PRODUCT COMMUNICATION | NOVEMBER 2023

# TFIO Modules – Analog Input (AI) Module Firmware Update

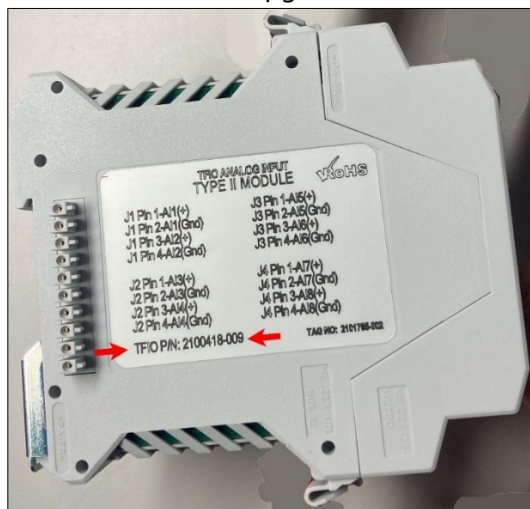
In October 2023, ABB was made aware of potential issues with TFIO Analog Input (AI) modules solely related to part number **2100418-009**. To mitigate the post-COVID supply chain crisis, ABB introduced this AI module version in Q2 2022. During certain circumstances, after a power reset, the AI module does not restart correctly. This causes the analog input reading to become uncalibrated.

ABB recommends upgrading all AI modules with part number 2100418-009 to the latest software firmware version. Please note that the firmware in previous versions of the AI Modules works correctly and does not need to be upgraded.
